SUBJECT: SURRY POWER STATION, UNIT NOS. 1 AND 2, ISSUANCE OF AMENDMENTS REGARDING REVISION OF TECHNICAL SPECIFICATION 5.0, "DESIGN FEATURES" (TAC NOS. MD8426 AND MD8427)

The U.S. Nuclear Regulatory Commission has issued the enclosed Amendment No. 262 to Renewed Facility Operating License No. DPR-32 and Amendment No. 262 to Renewed Facility Operating License No. DPR-37 for the Surry Power Station, Unit Nos. 1 and 2, respectively. The amendments change the Technical Specifications (TSs) in response to your application dated April 2, 2008.

SAFETY EVALUATION BY THE OFFICE OF NUCLEAR REACTOR REGULATION

SURRY POWER STATION, UNIT NOS. 1 AND 2

Figure 5.3-1  
MINIMUM FUEL EXPOSURE VERSUS INITIAL ENRICHMENT  
TO PREVENT CRITICALITY IN DAMAGED RACKS

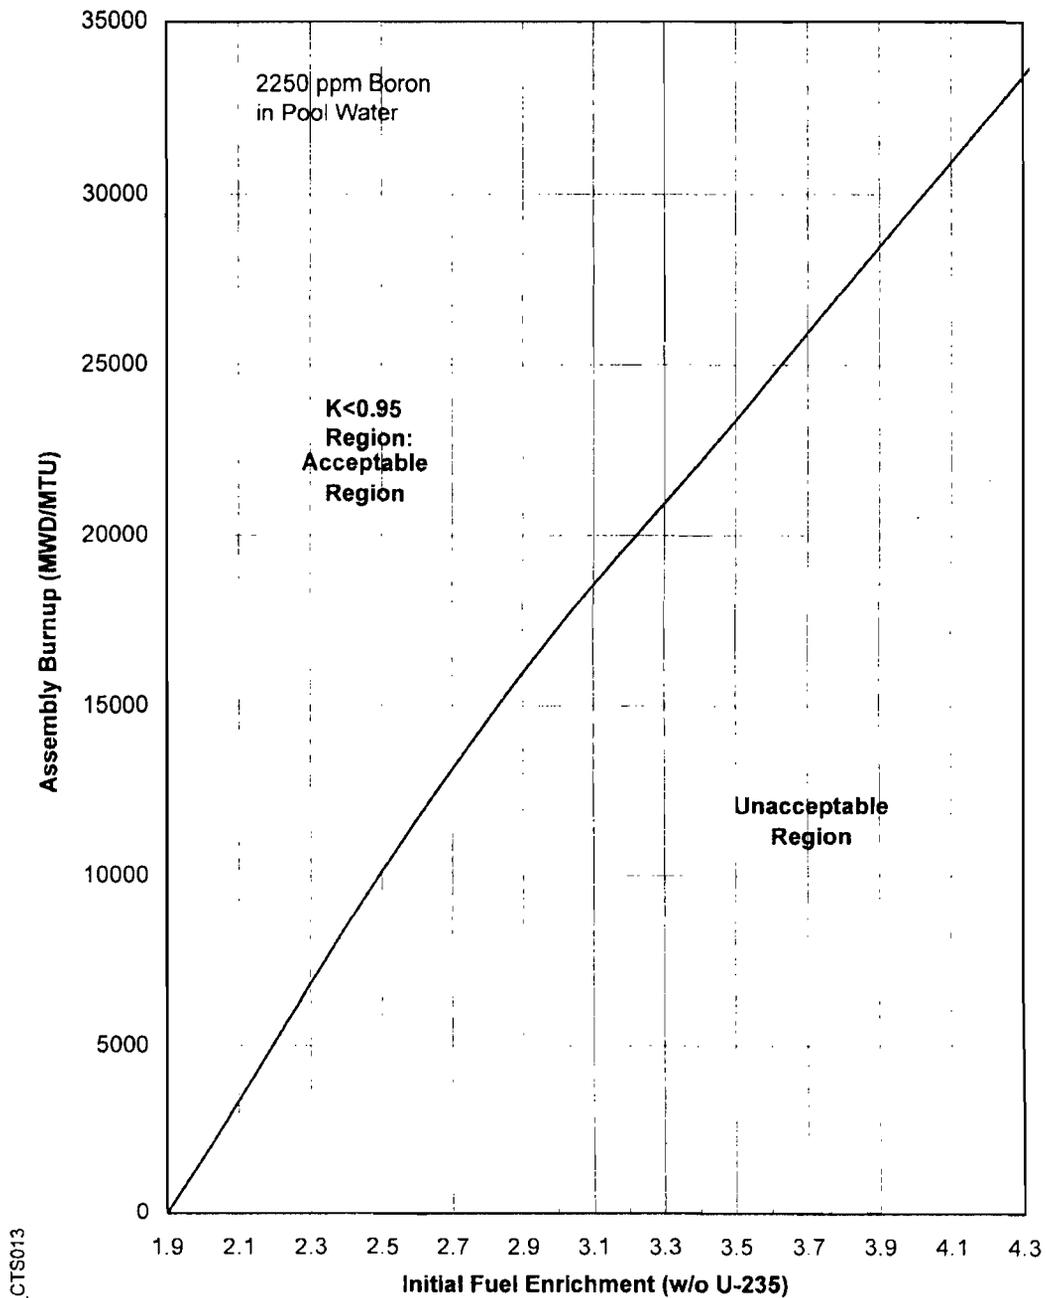
- h. Add TS 5.3.3 to include a limit for spent fuel pool level,
- i. Add TS 5.3.4 to incorporate the limit for spent fuel pool storage capacity,
- j. Renumber TS Figure 5.4-1 as TS Figure 5.3-1.
